# Quiet Zone Implementation Study

**CITY OF MENLO PARK AND CITY OF PALO ALTO QUIET ZONE STUDY**

**Grade Crossing Improvement Diagnostic Meeting for  
Encinal Av Crossing (DOT 754988Y) in Menlo Park, CA  
Tuesday, December 13, 2022**

ENCINAL AV XING

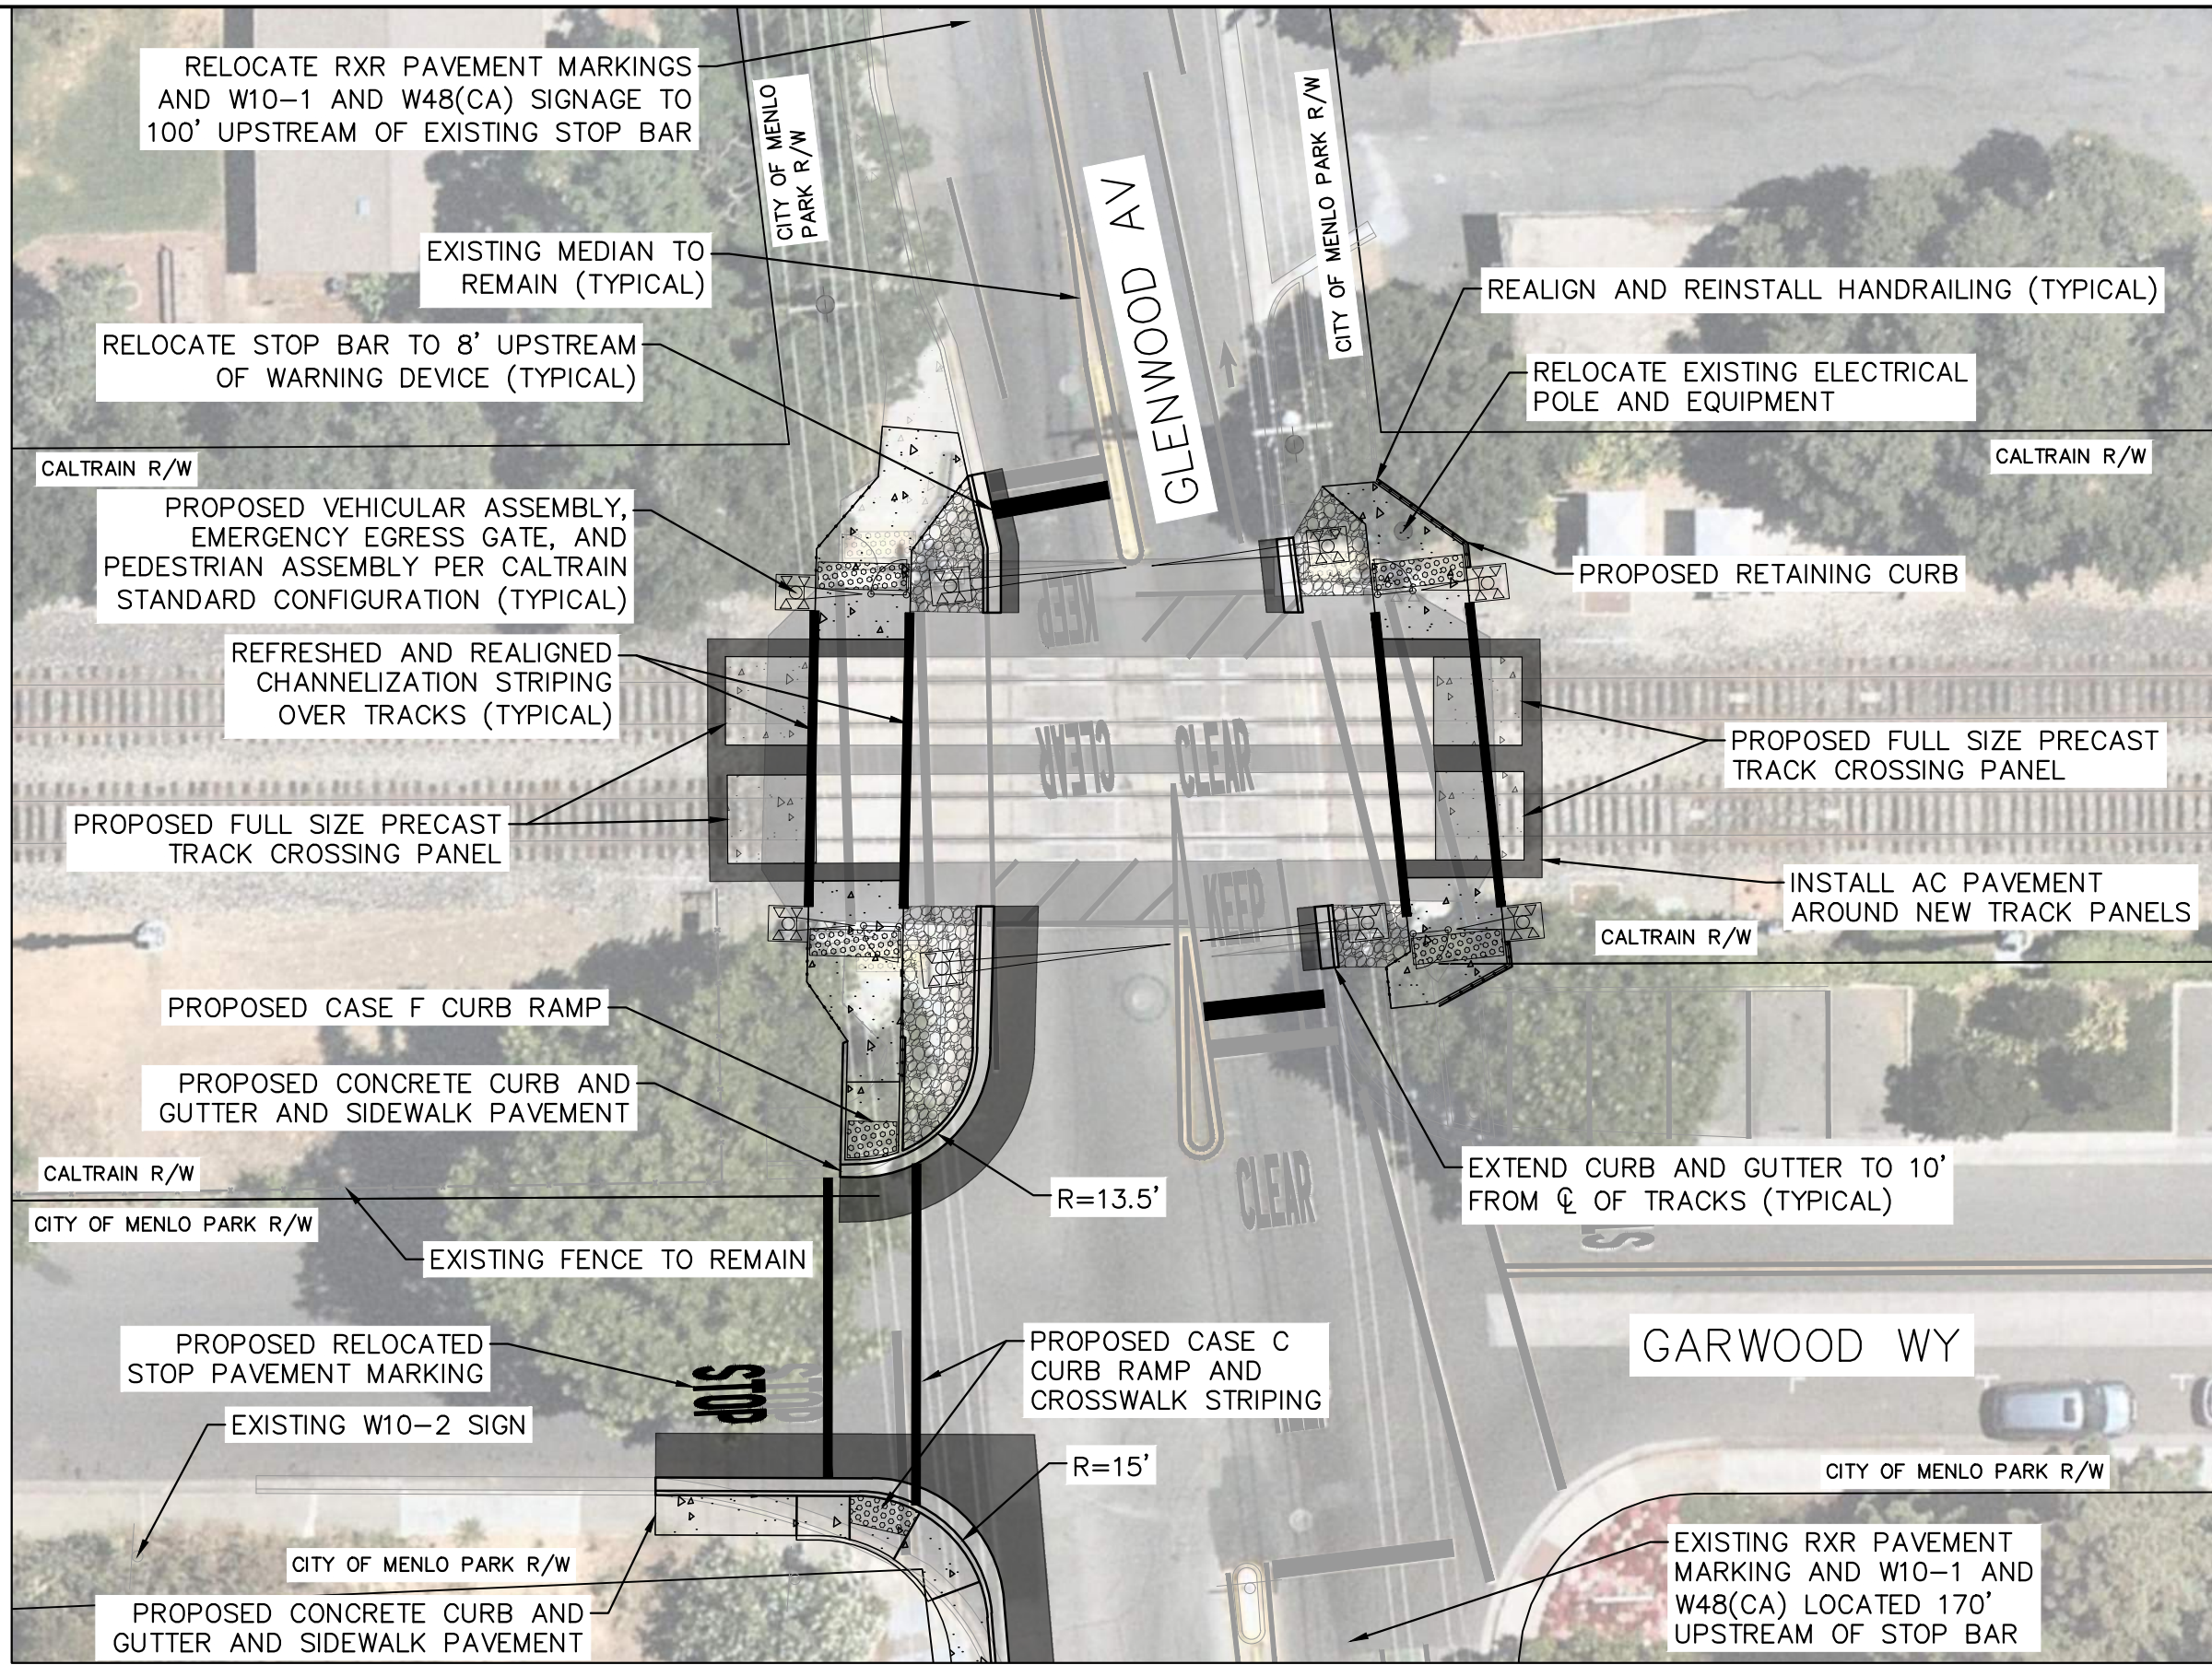
- The diagnostic team noted the sidewalk reconfiguration in this quadrant would necessitate vegetation trimming/removal.
- Caltrans noted the location of asphalt and sidewalk meeting is not flush and poses a tripping hazard.
  - Kimley-Horn indicated that the asphalt in front of the sidewalks would be replaced, as sidewalk is proposed to extend up to 2' from the crossing panels, and a note can be added to ensure the meeting point of concrete sidewalk and asphalt is flush in all locations.
  - Diagnostic team discussed potential of replacing existing rough asphalt all the way up to the crossing panels, rather than using rough aggregate asphalt currently in place.
- Diagnostic team noted this quadrant may be a candidate for streetlighting.

- Diagnostic team discussed tie-in of proposed sidewalk and proximity to R/W. While close, it does not require any R/W acquisition.

- Diagnostic team discussed existing medians and potential for upgrades; current design shows medians to be left as-is.
- Note existing W10-4 signage on Garwood Way is located adjacent to a large shrub that can block the visibility of the sign.
- CPUC noted the crosswalk (which connects pedestrians in Location 3 with Location 4) as an area of concern. Aside from it being installed without prior approval, its proximity to the crossing poses a potential queueing concern. CPUC would like a queue study to be performed at this location.
  - City of Menlo Park stated they will conduct a queueing study and are planning to undergo the process to obtain approval for the crosswalk.
  - City of Menlo Park indicated this crosswalk serves a relatively small population and may not be a queueing concern. Video traffic counts can be revisited to see if queueing due to the crosswalk can be seen.

- Improvements would push infrastructure up to the maintenance access gate.
  - Caltrain believes current access is made by turning onto the tracks from the SB approach. With the upgrades Caltrain is undergoing currently, it is unclear if maintenance access will be needed or what that will require spatially.

- Kimley-Horn will draft Diagnostic Notes and provide to the Diagnostic Team for review/concurrence.
- Kimley-Horn will update the concept design to upgrade signage and striping, as well as add “no train horn” signage for pedestrians.

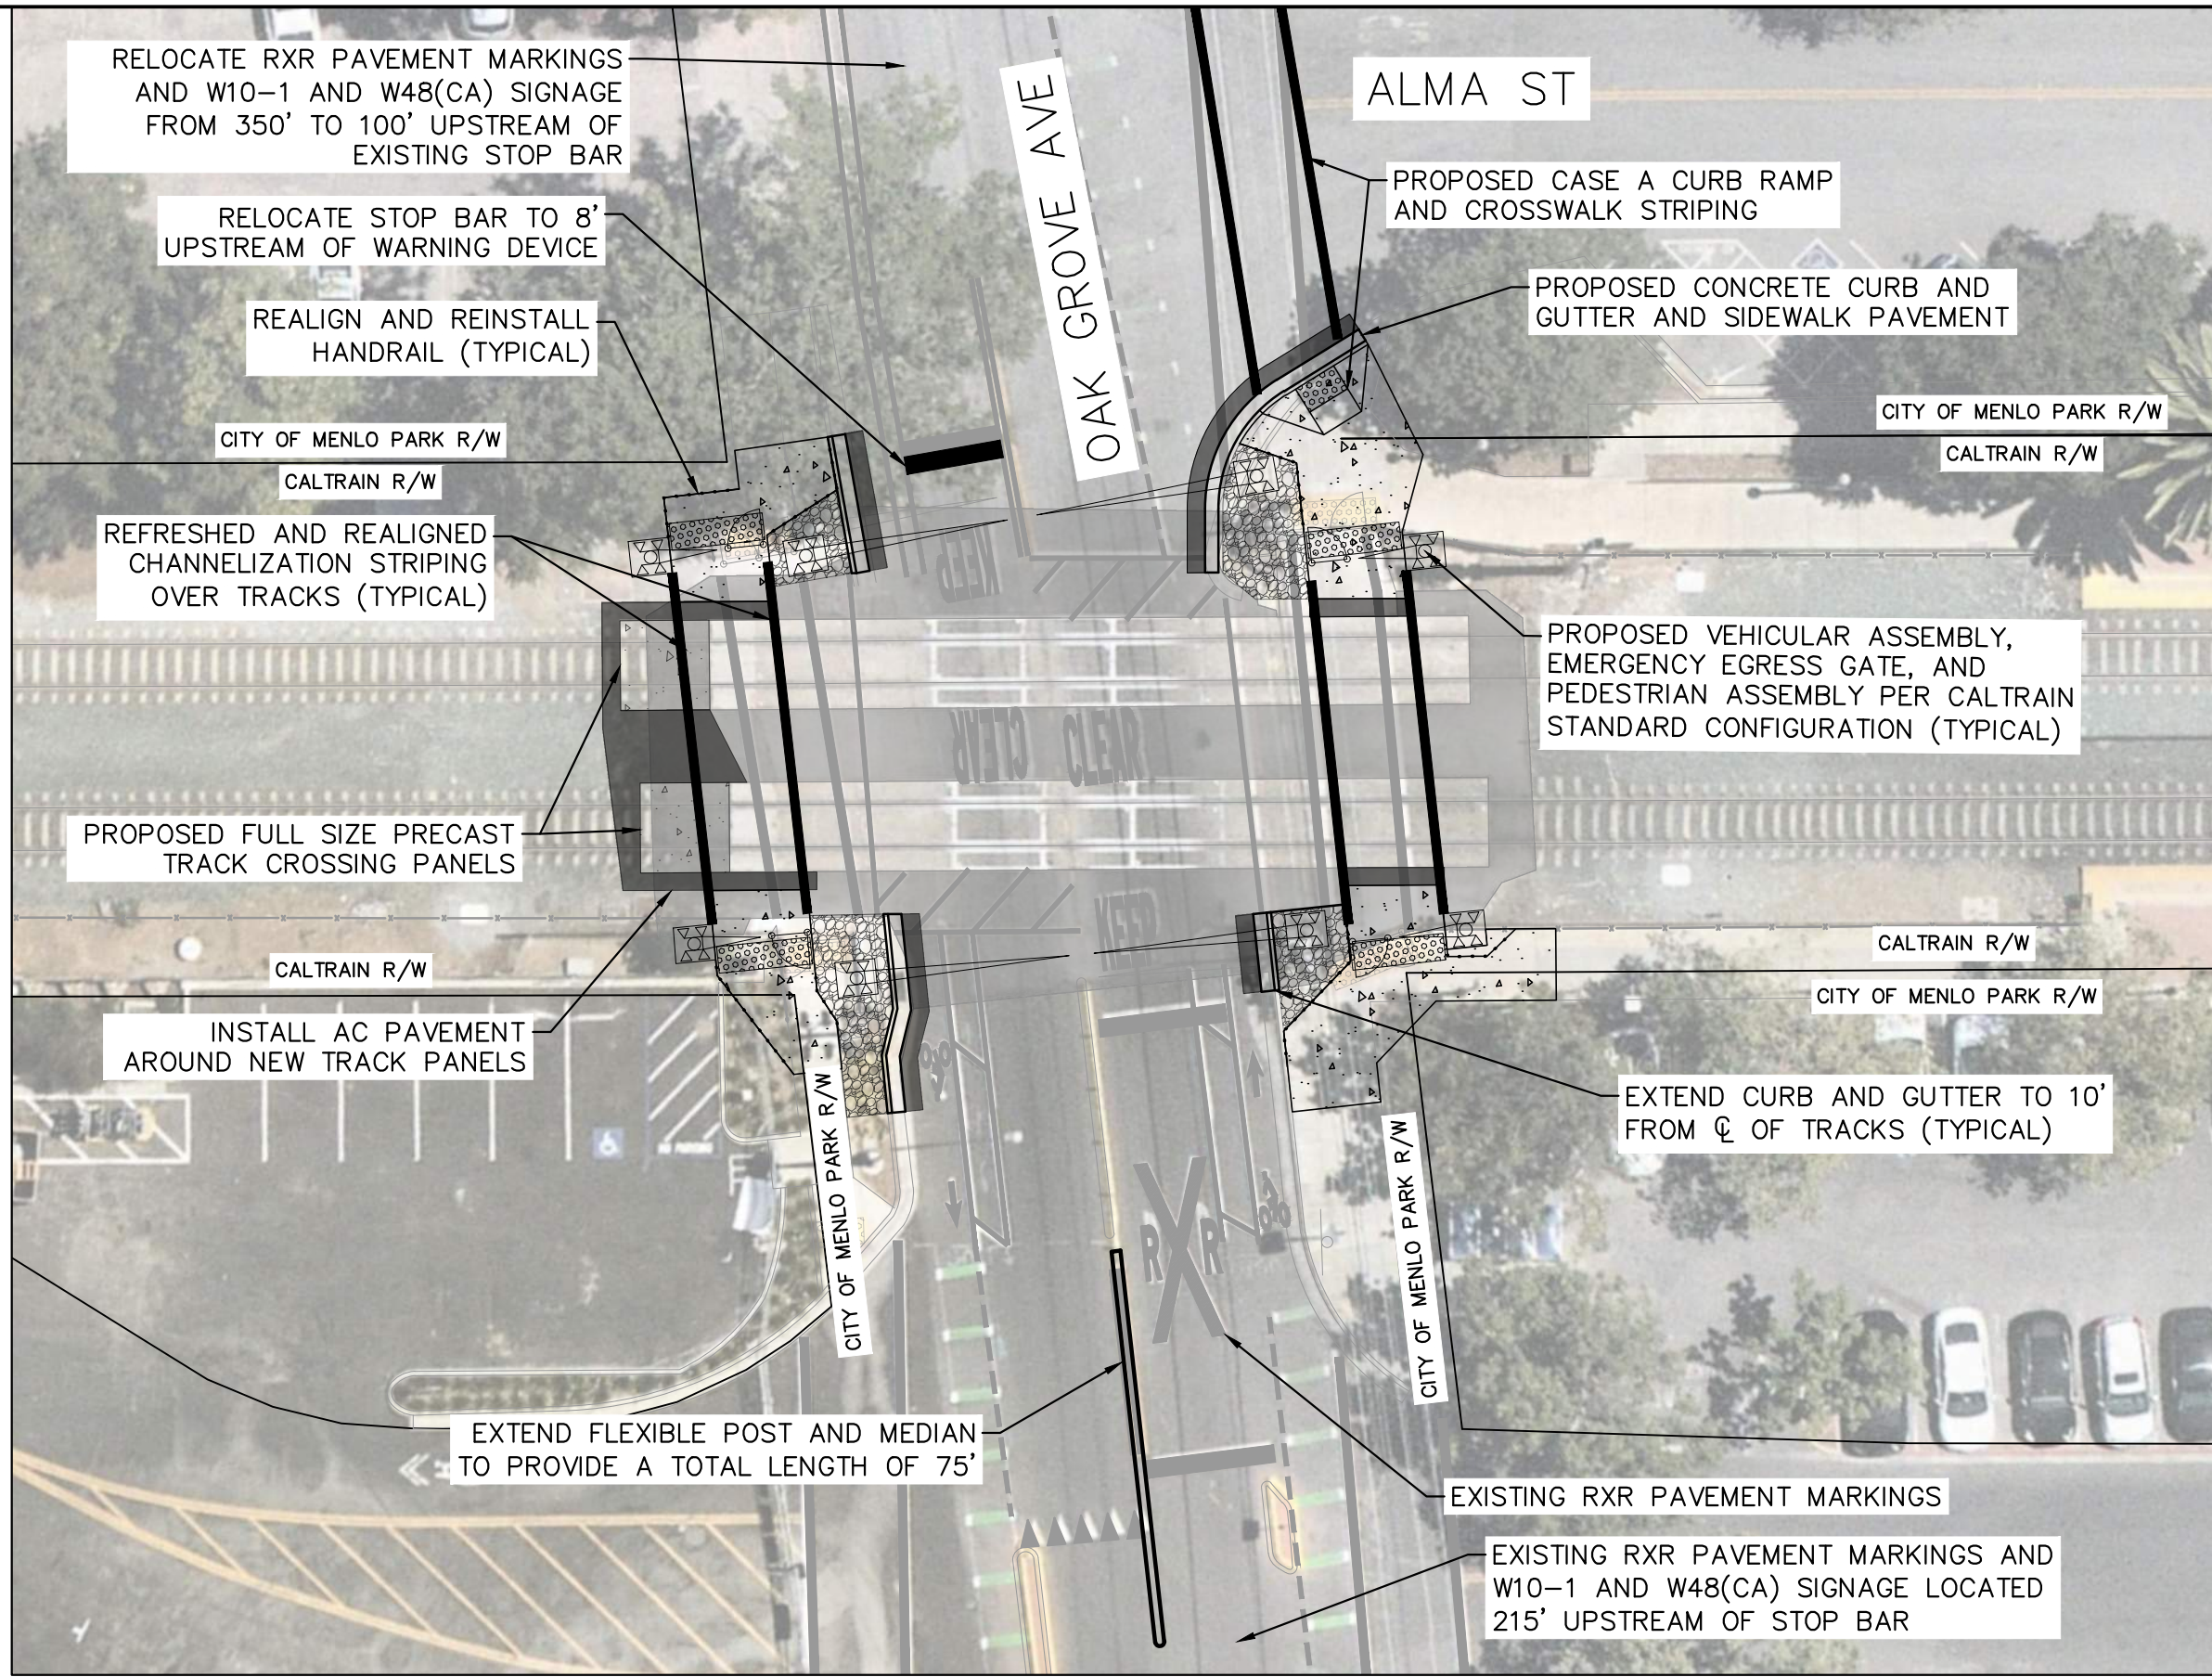
- The diagnostic team noted the sidewalk reconfiguration in this quadrant would necessitate vegetation trimming/removal. At least one tree would require removal within Caltrain R/W, as well as shrubbery in the City R/W.

- Diagnostic team discussed relocation of service meter on aboveground post, as it conflicts with proposed sidewalk reconfiguration.
  - Caltrain indicated that aboveground wires aren't used anymore, and the wires would instead be relocated and installed underground.

- Diagnostic team discussed lack of raised median between tracks and Garwood Way. Caltrain indicated this could be due to a lack of City permission at the time of installation, or due to access concerns.
- FRA measured distance from current stop bar to gate, which appears to be close to 10'. Proposed improvements show stop bar being relocated to 8' upstream of proposed warning devices.
- Diagnostic team noted W10-2 signage located on Garwood Way.

- Diagnostic team noted W10-2 signage located on Garwood Way.

- Kimley-Horn will draft Diagnostic Notes and provide to the Diagnostic Team for review/concurrence.
- Kimley-Horn will update the concept design to upgrade signage and striping, as well as add "no train horn" signage for pedestrians.
